MECKLENBURG COUNTY
Health Department

Re: Application for improvement permit for:
Property Site: Belt Rd. parcel 5533-46-9747
Health Department file number: **6421B**

SOIL/SITE EVALUATION
for ON-SITE WASTEWATER SYSTEM

Sketch of Soil Evaluation Locations

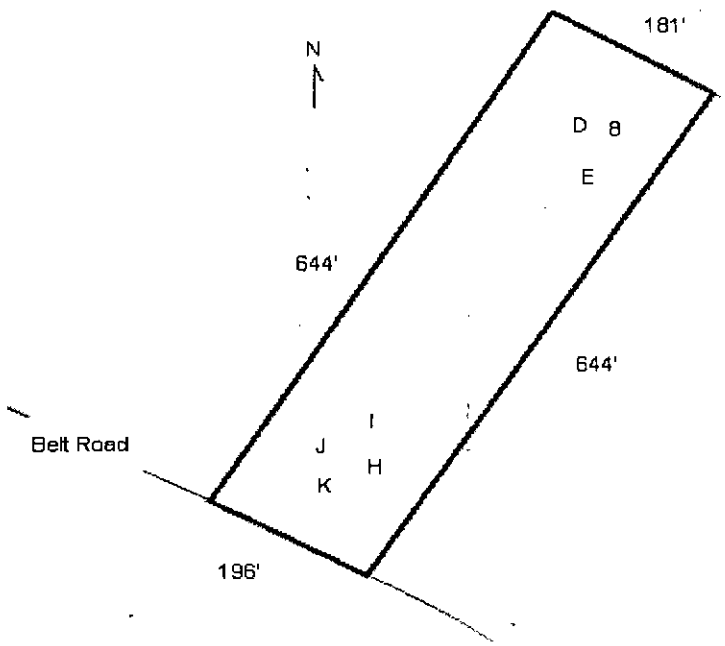
Other Factors (.1946):
Site Classification (.1948): UNSUITABLE
Evaluated By: W. R. Marlin, LSS, 5/26/2006, W. R. Marlin
Others Present: J. Beeson

COMMENTS:
100% repair

Sketch of Soil Evaluation Locations

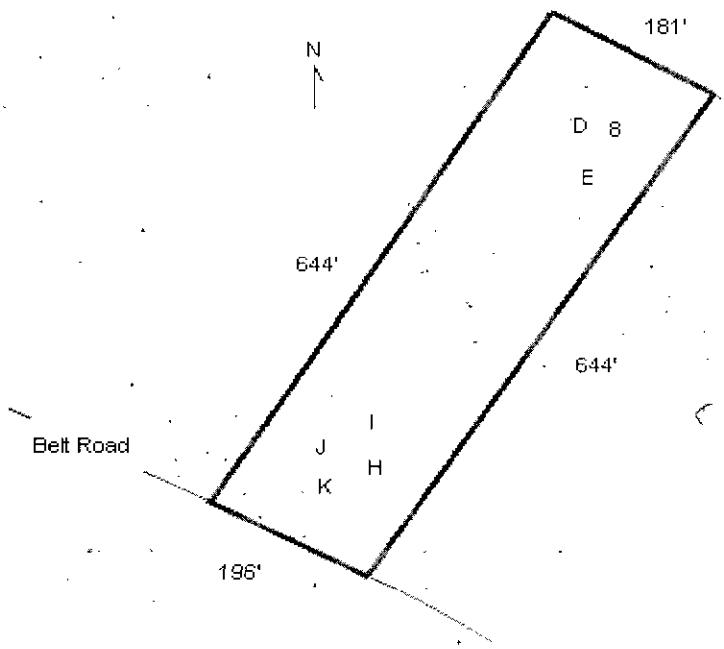
Other Factors (.1946):
Site Classification (.1948): UNSUITABLE
Evaluated By: W. R. Marlin, LSS, 5/26/2006,
Others Present: J. Beeson
Site Evaluation: David Cornelius, RS

COMMENTS:
100% repair
